COMMUNITY PLANNING DEPARTMENT
STAFF REPORT AND RECOMMENDATION TO
THE HEARING EXAMINER

FILE No: PP 20-02/PLN-2020-02594

Summary of Proposal: A Preliminary Plat proposed to subdivide 41.07 acres into a total of 97 lots and 5 tracts.

APPLE VALLEY - PHASE 6

COK Standard Drawing No. 2-9

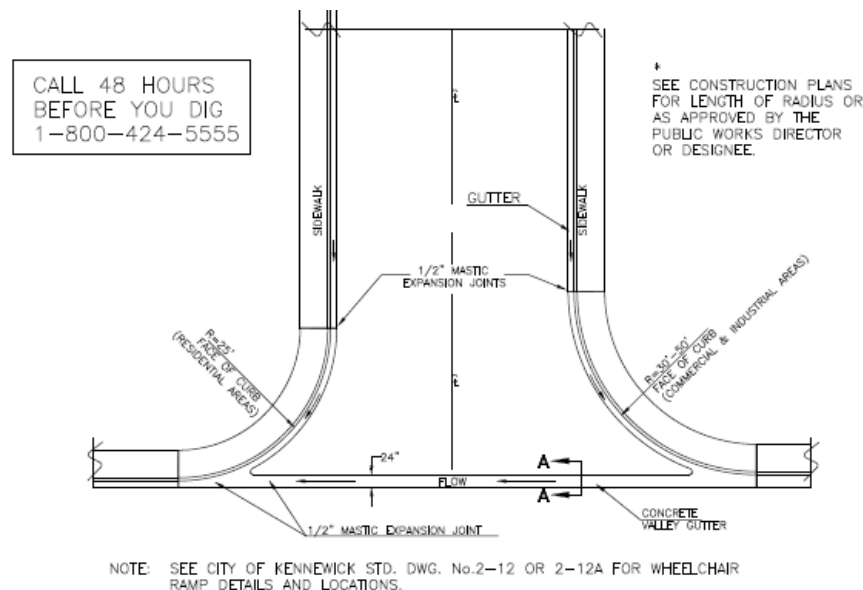
1. Please refer to COK Standard Drawing No. 2-9 below. Provide civil design layout for roadway intersections to verify right-of-way limits and minimum intersection radius.
